**Millstone Power Station Unit 2 GSI-191 Generic Letter 2004-02
Corrective Actions Audit Report**

Millstone Power Station, Unit 2 (Millstone Unit 2 or MP2) is operated by Dominion Nuclear Connecticut, Inc., the licensee.

Figure 3.6.1.3.2-1 Walnut Shell Flour Particle Size Distribution

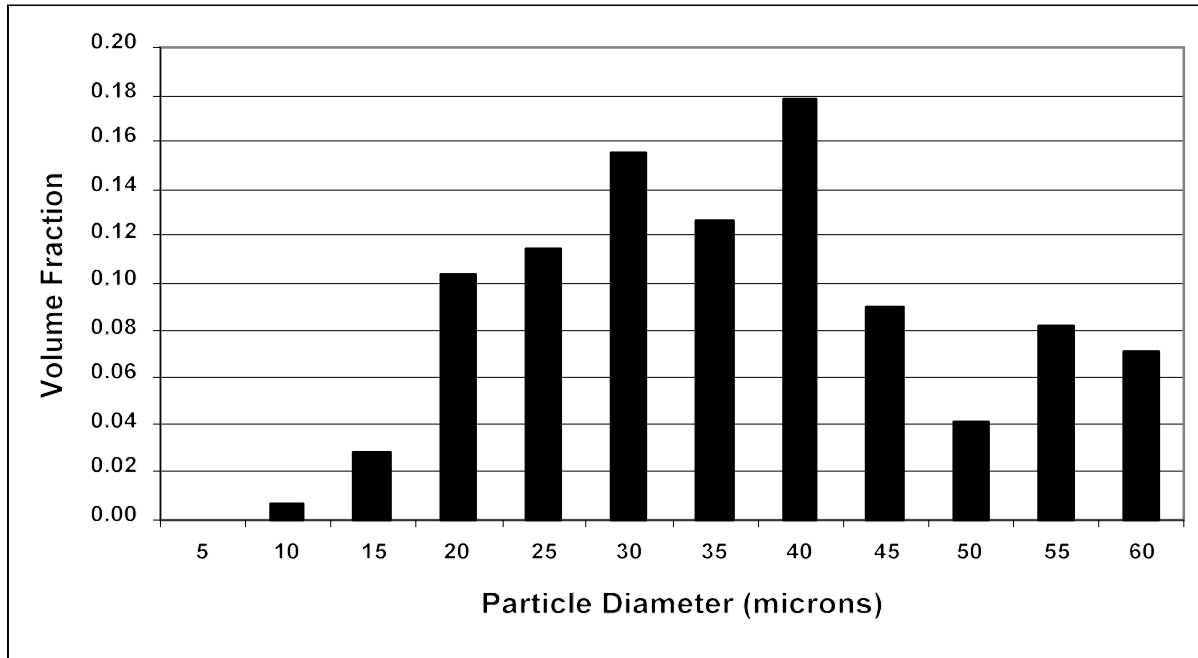
With regard to the head loss characteristics of the walnut flour, the only information provided directly to the NRC staff was a particle size distribution obtained from the manufacturer. This size distribution, which is converted to volume fractions, is shown in Figure 3.6.1.3.2-1 below [125]. A detailed comparison of the walnut flour with coatings particulate was not available for review. The AECL analysis [page 5-3 of 124] of the walnut particle size distribution determined that the average size was about 23 µm, and (from a specific surface area consideration based on spherical particle shape assumption) the effective particle size was about 32 µm. This means that the walnut flour particles were a factor of about 3.2 larger than the GR recommendation, which translates to a factor of 10 decrease for head loss impact. Note that at the very low approach velocities associated with the Millstone replacement strainer, the head loss is approximately linear with the square of the specific surface area [123]. The specific surface area for the wallnut flour size distribution, assuming spherical particles, is about 57,000

ft²/ft³, as compared to 183,000 ft²/ft³ for the SE-assumed particulate. Therefore, if only the walnut flour hydraulic characteristics are considered, a conclusion could be drawn that walnut flour may not be a good surrogate material to meet GR and SE coatings requirements.

Figure 3.6.1.3.2-2 Walnut Shell Flour Specific Surface Areas Experimentally Deduced by NRC Staff from Thin-Bed Tests

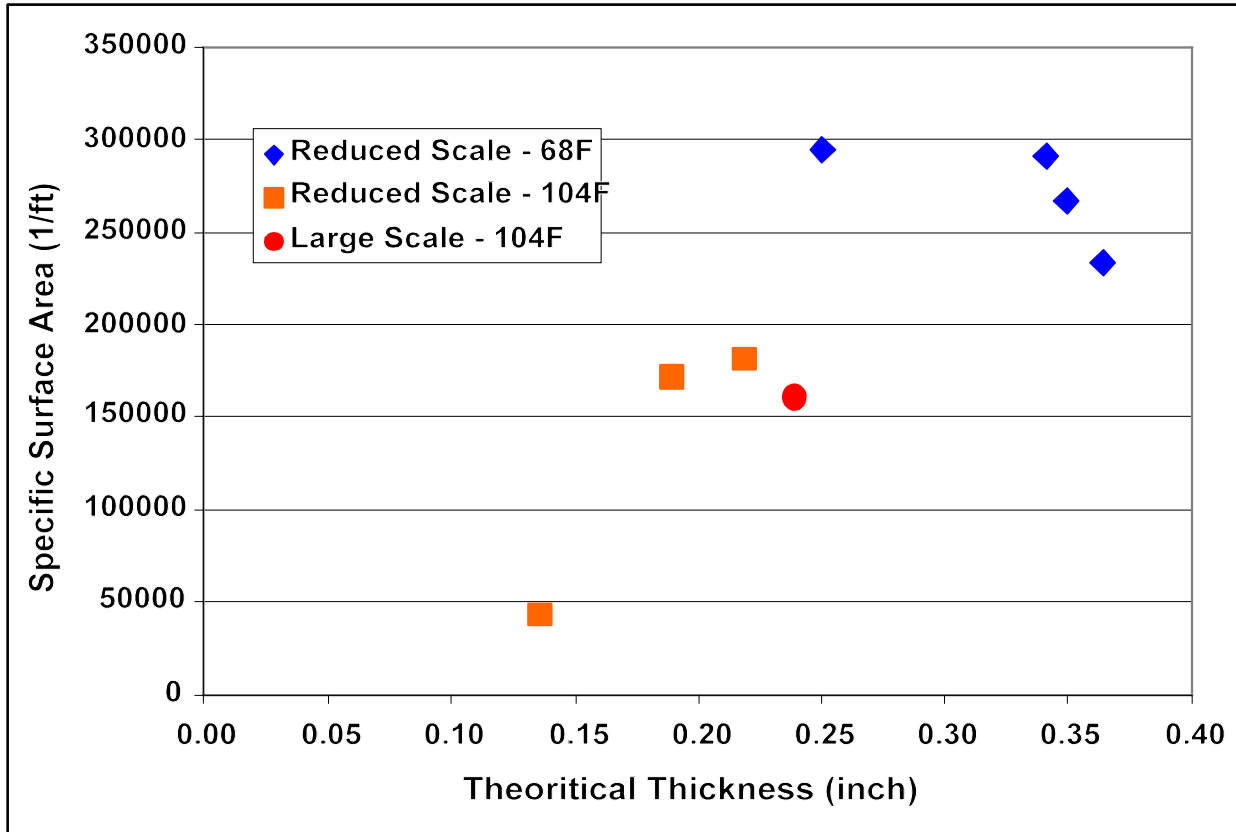
The following observations were made from Figure 3.6.1.3.2-2:

- The staff deduced specific-surface area values for walnut shell flour, which are shown in Figure 3.6.1.3.2-2. These values are close to that for hypothetical 10 μm spherical particles (183,000 ft²/ft³) found in the GR [1]. As demonstrated in [11], head loss characteristics are strongly correlated to specific surface area. Therefore, the experimental evidence strongly indicates that the head loss characteristics of the walnut shell flour are close to the GR-recommended 10 μm spherical particle, and may even be conservative with respect to the GR guidance.
